Proposal: The application requests to approve an expansion to a permitted manufactured home sales center at the end of Palm Harbor Drive. The expansion has been operating without the benefit of permits; this permit seeks to rectify this. The permit will allow a sales center on (portions of) three parcels, an on-site office (in 2 structures), up to 26 home displays, 13 parking spaces, and landscaping. The site uses the 26 displays as model homes as well as direct sales of units and inventory as it rotates. Additionally, the applicant is requesting to permit a series of existing signs up and down Palm Harbor Drive.

- A. Applicant: Palm Harbor Homes
- B. Location: 3737 NE Palm Harbor Drive
- C. Review Type: The applicant is requesting two separate permits, a Site Development Review Land Use Permit, and a Sign Permit. The proposed Site Development Review requires a hearing before the Planning Commission because it is a Type III action. The Sign Permit request is a Type I permit, which is normally processed at the staff level; however, because the Site Design Review and the Sign Permit were submitted together, Development Code Section 5.16.010 explains that both are processed at the hi

FIGURE D103.1
DEAD-END FIRE APPARATUS ACCESS ROAD TURNAROUND

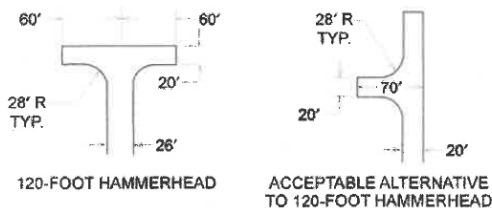
1. Approved fire apparatus roadways must extend to within 150 feet of all exterior portions of any structure that will be built on the property as measured by an approved route of travel around the exterior of the structure. (OFC 503.1.1)
2. Dead-end fire apparatus roads in excess of 150 feet in length shall be provided with an approved area for turning around fire apparatus (OFC 503.2.5 and D103.4)

A turnaround is required due to the length of the access road. Future plans shall indicate where the turnaround will be located.
